SPECIFICATION, SPECIAL PROVISIONS AND DRAWINGS (OLD BUSINESS ITEM)
REVISION TO STANDARD SPECIFICATIONS, SPECIAL PROVISIONS, AND DRAWINGS

PROPOSAL TO STANDARDS COMMITTEE

REVISION TO SPECIFICATIONS, PROVISIONS AND DRAWINGS (OLD BUSINESS ITEM)
SECTION 805 – TRAFFIC SIGNALS

805-SGCF-04 SIGNAL HANDHOLE (REVISED DRAFT)

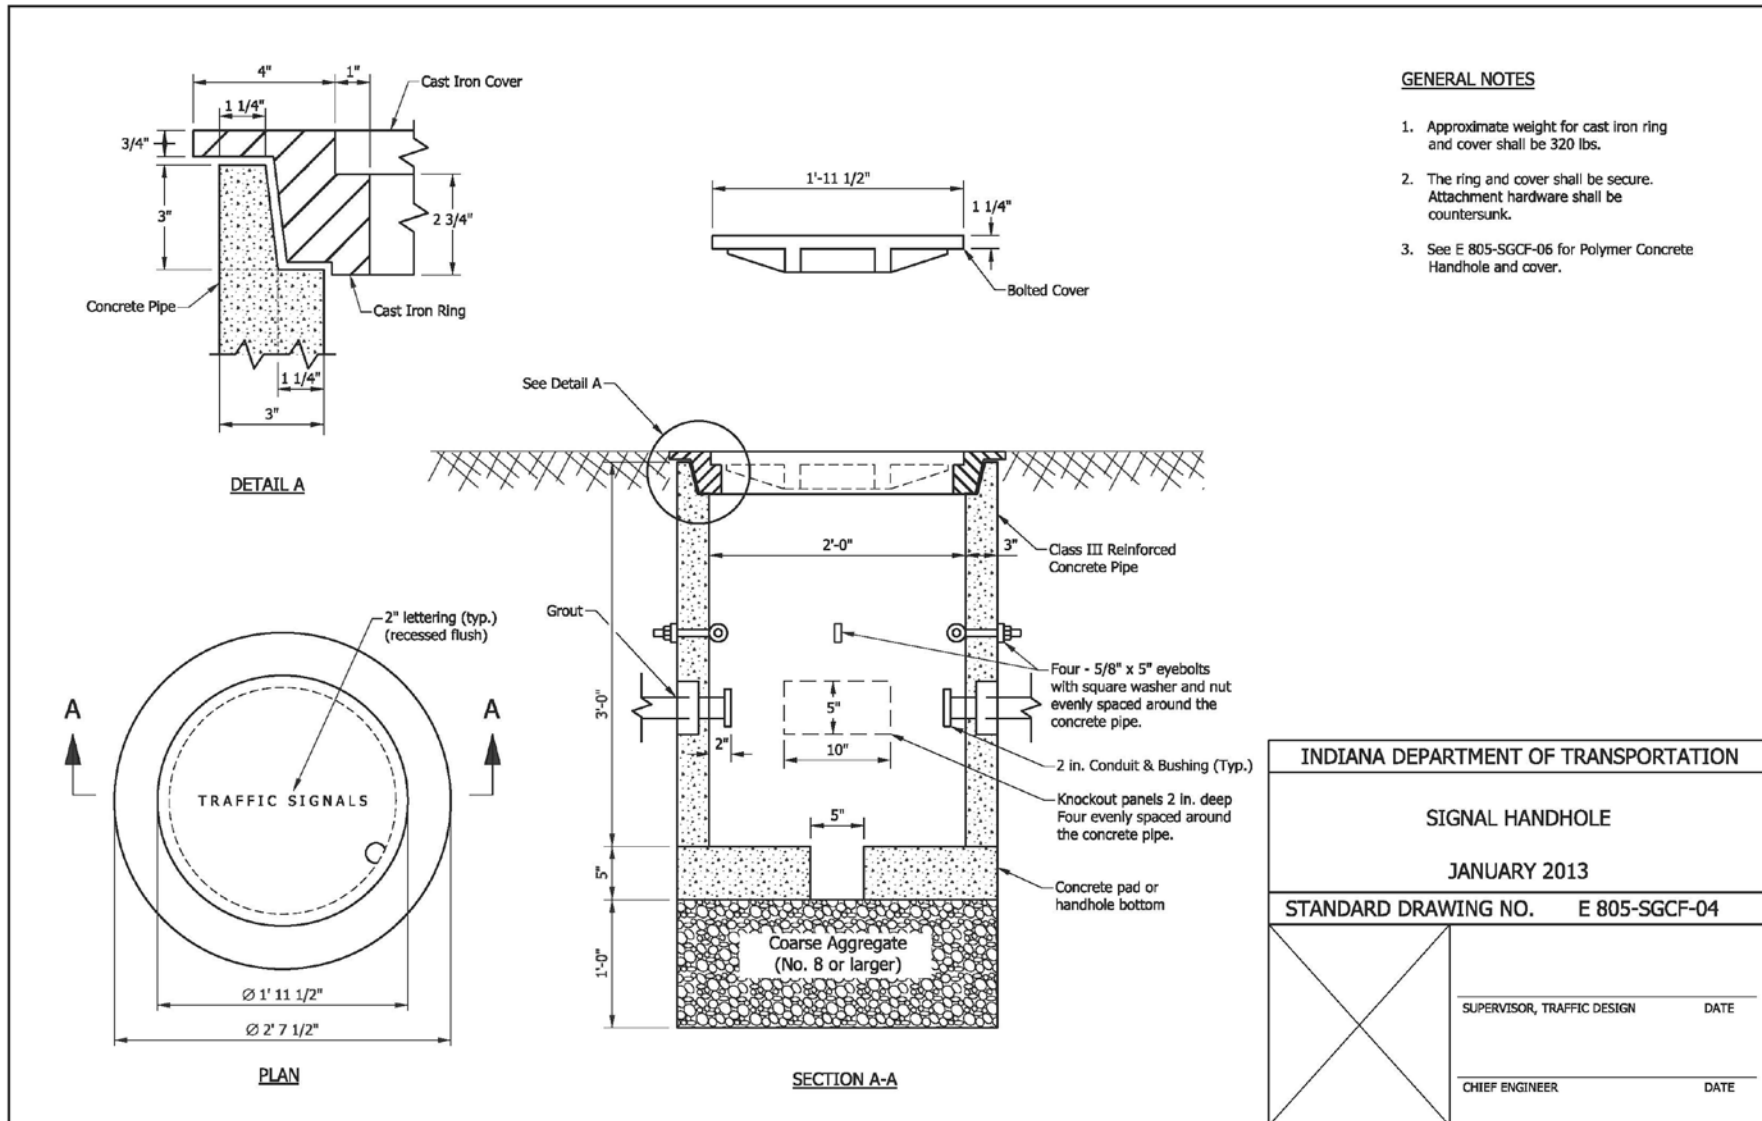
Revise Standard Drawing 805-SGCF-04 for concrete handholes and create a version for polymer concrete handholes. Delete Standard Drawing 805-SGLT-01.

PROPOSED NEW 805-SGCF-04A SIGNAL HANDHOLE POLYMER CONCRETE TYPE

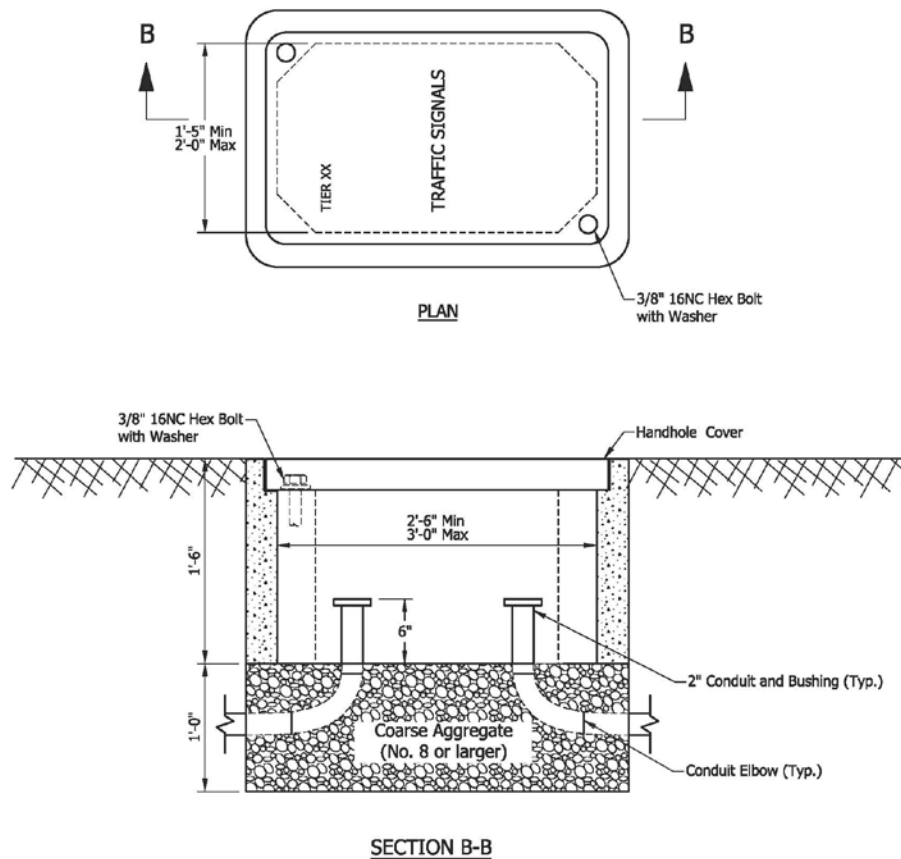
Please note that sections 805.02, 805.16 and 922.17 of the INDOT *Standard Specifications* are being revised and Standard Drawing to allow the use of polymer concrete handholes.

EXISTING 805-SGLT-01 LOOP TAGGING SYSTEM (PROPOSED TO DELETE)

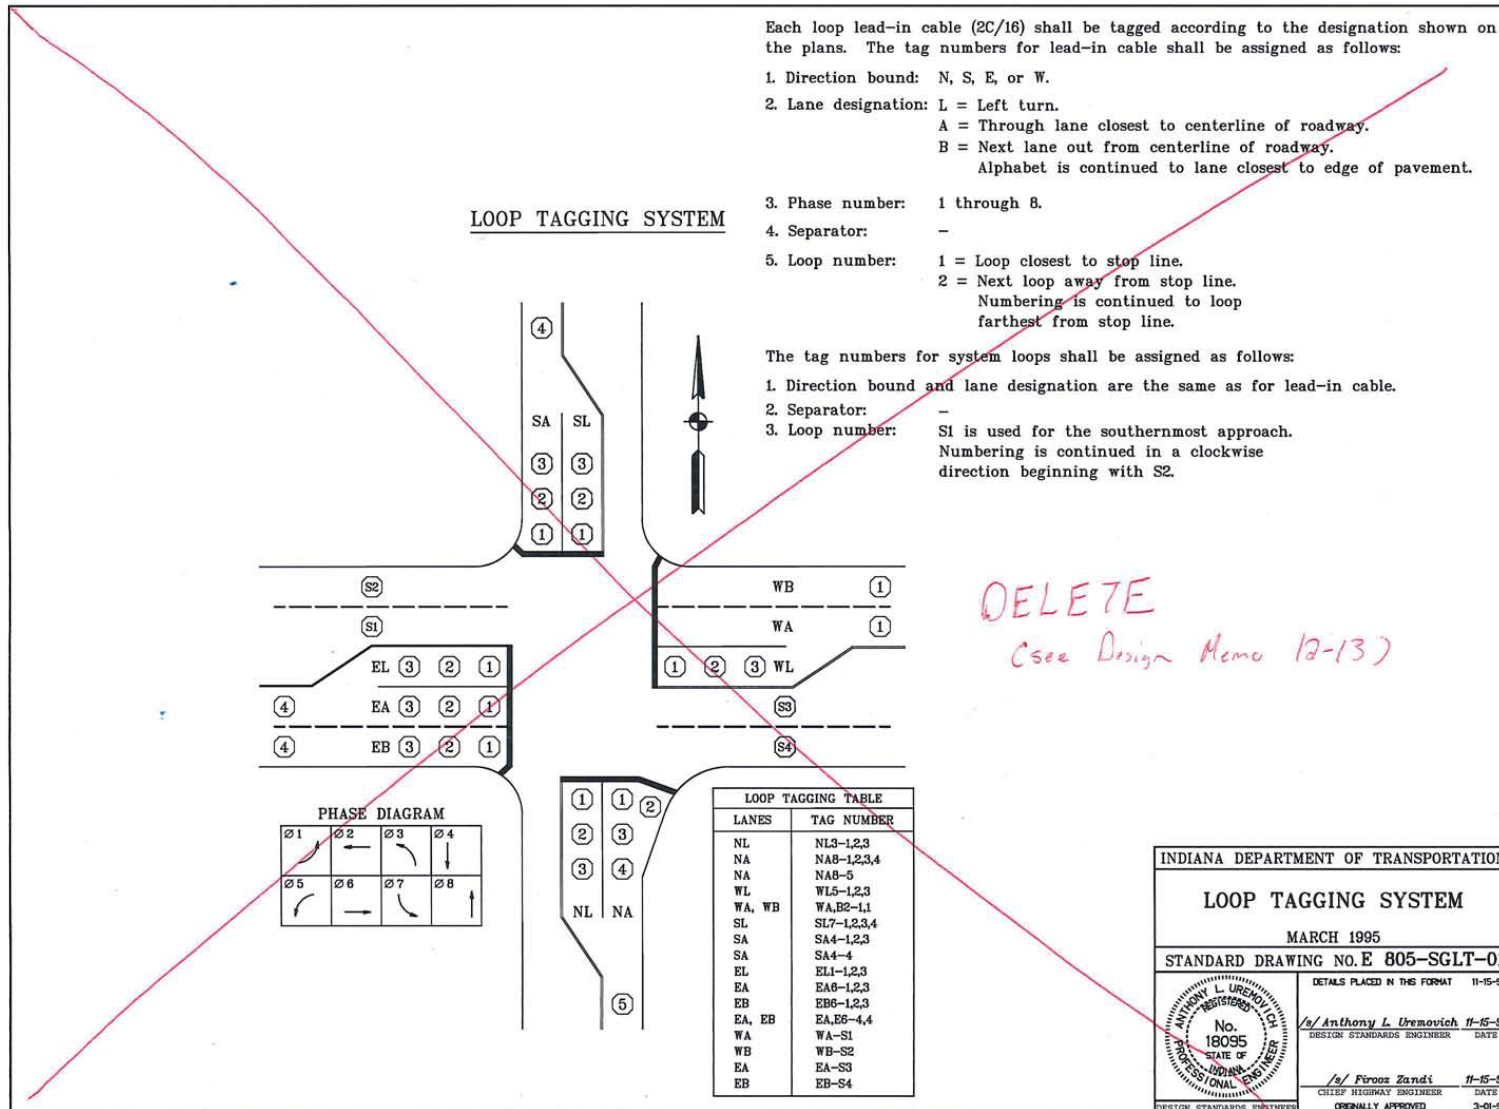
Standard Drawing 805-SGLT-01 detailing the loop tagging table is not accurate and is redundant after Design Memo 12-13.

EXISTING 805-SGSC-03 CABLE SPAN ATTACHMENT (WITH MARKUPS)

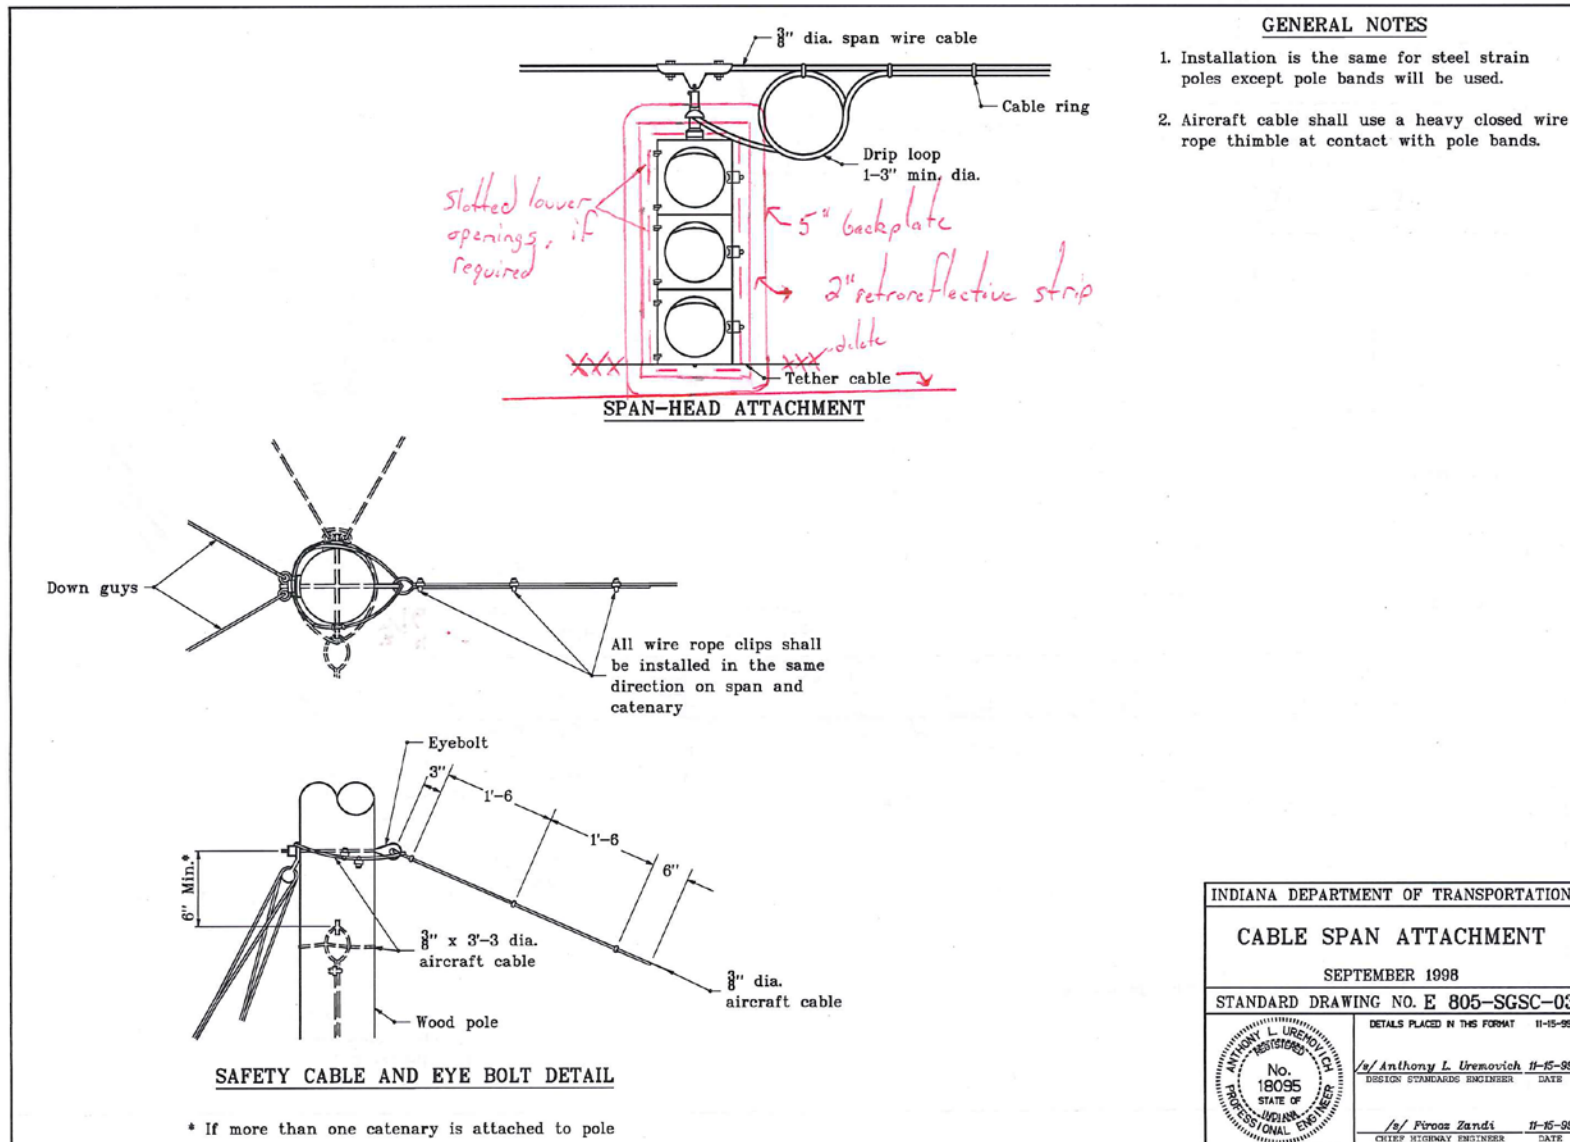
APPLICABLE STANDARD DRAWINGS: 805-SGLT-01, 805-SGCF-04; 805-SGSC-03, -04
